LIST OF STANDARD DRAWINGS APPLICABLE FOR 245kV IVT

CUSTOMER : APTRANSCO				
4		GEN. TOL.	MATL.:	TITLE : LIST OF STANDARD DRGS. / DOCUMENTS APPLICABLE FOR 245 kV IVT (CREEPAGE = 25 mm/ kV)
3			SPEC.:	
THIRD ANGLE PROJECTION				
2		SCALE: NTS	INITIALS	NAME
1		ALL DIMNS. IN MM. UNLESS OTHERWISE SPECIFIED.	ORG	NSB
			CHD	PBN
			APPD	USS
NO	REVISION	SIGN	DATE	DATE : 12.02.2021
DRG.NO: 3-VAD 3377				REV 0

GEN. TOL.	MATL.:	TITLE : STANDARD DRAWING GENERAL ARRANGEMENT OF 245 kV IVT (CREEPAGE = 25 mm/ kV)
	SPEC.:	
THIRD ANGLE PROJECTION		
SCALE: NTS	INITIALS	NAME
ALL DIMNS. IN MM. UNLESS OTHERWISE SPECIFIED.	ORG	NSB
	CHD	PBN
	APPD	USS

**SCHEDULE OF TECHNICAL & GUARANTEED PARTICULARS**  
**FOR 245kV POTENTIAL TRANSFORMER**

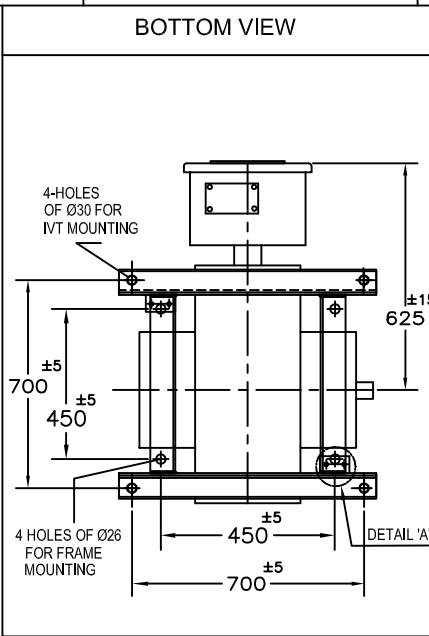
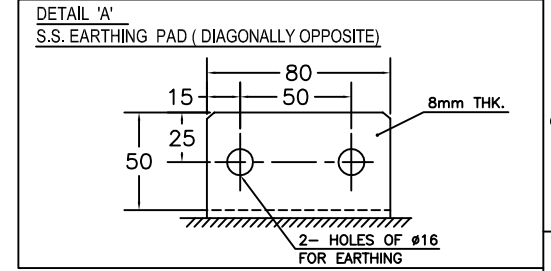
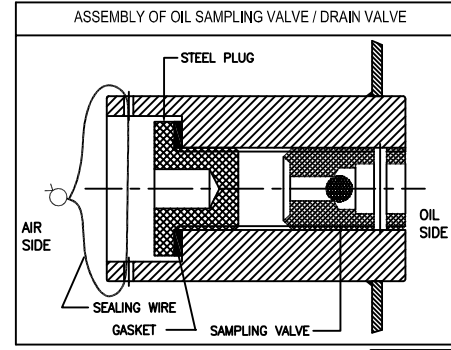
Drawing approval subject to valid vendor registration

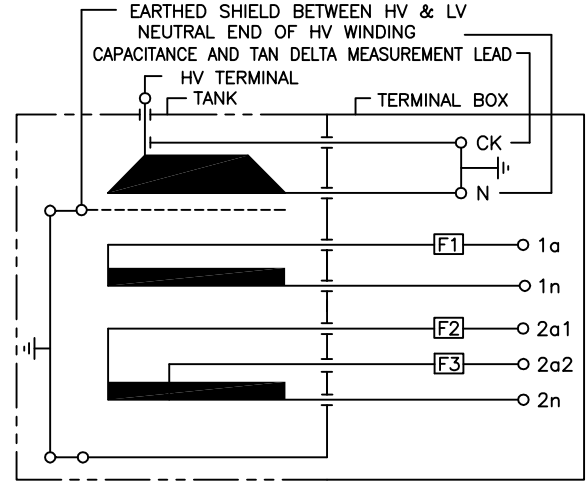
NOTE : DRAWING APPROVAL SUBJECT TO VALID TYPE TEST REPORTS, TO BE CHECKED DURING ACCEPTANCE TESTS.

- 1). Minimum 300 mm Plinth shall be maintained for Current transformers in the substation during foundation works to ensure safe live to ground clearances as per IE rules.
- 2). Since the supply of terminal connectors is not in the scope of CT Manufacturer as mentioned in the drawings, the EPC contractors shall be instructed to supply the same in line with the CT requirement and compatibility.
